11 June 1956

MEMORANDUM FOR: THE RECORD

SUBJECT : Project Monitors at [REDACTED]
RD-61ss, Tasks I - IV

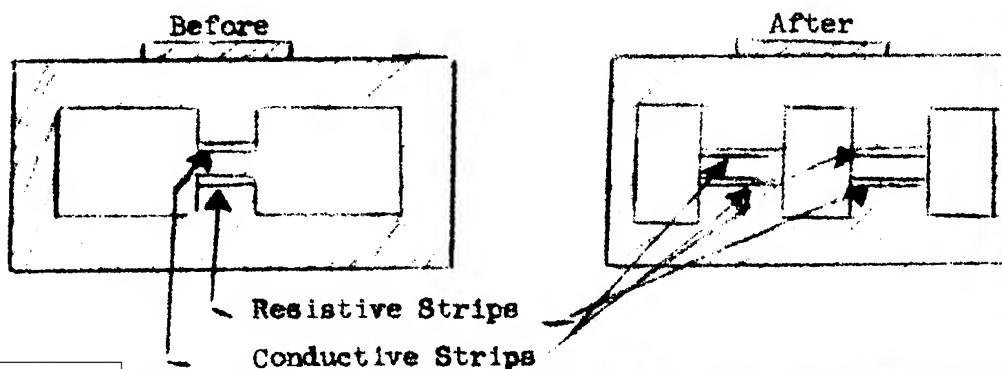
Since an average operating time of 4 hours per day is believed to be reasonable, it is apparent that a switching system allowing the monitor to be completely shut off when the [] is not in use will save a factor of 1/6 in battery size. To make this saving possible, [] has been requested to try the following modification in the transducer.

[] will report by 30 June the feasibility of this change. The basic decoder work at [] will be continued after the transducer modification. A thorough investigation of commercially available [] will be made. If possible, a complete [] decoder will be built although the present contract does not require it due to an extension of scope without increase of funds.

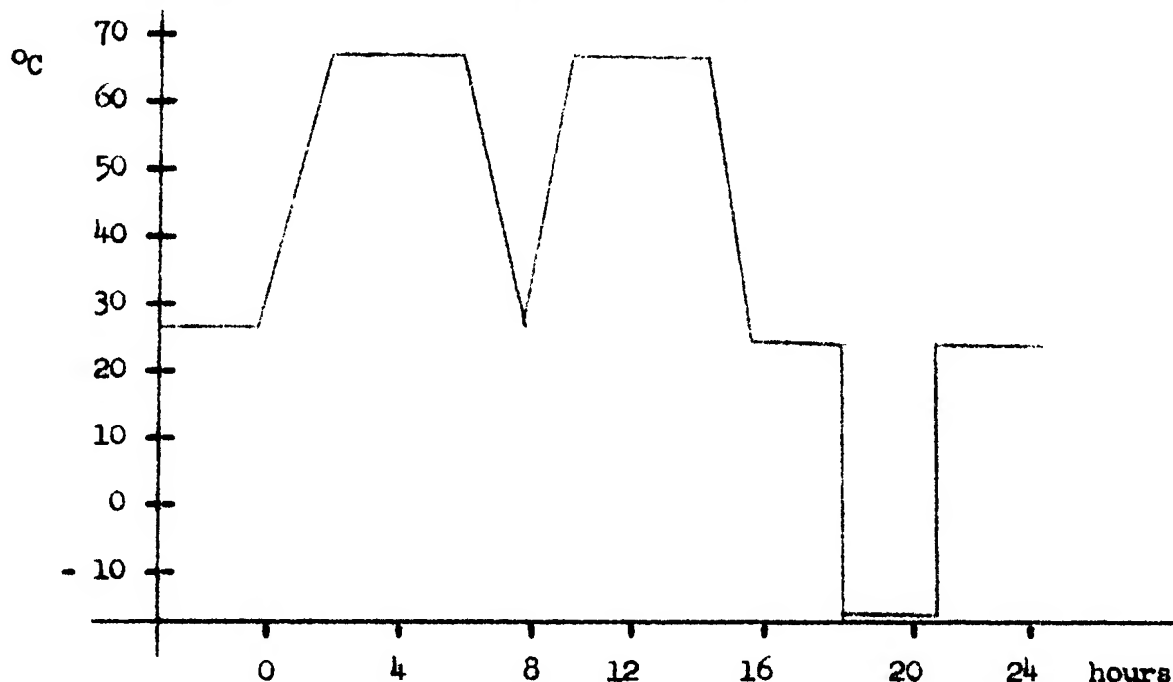
The equipment shall be subjected to temperatures of -54°C and $+71^{\circ}\text{C}$. For a period of 12 hours after equilibrium has been attained.
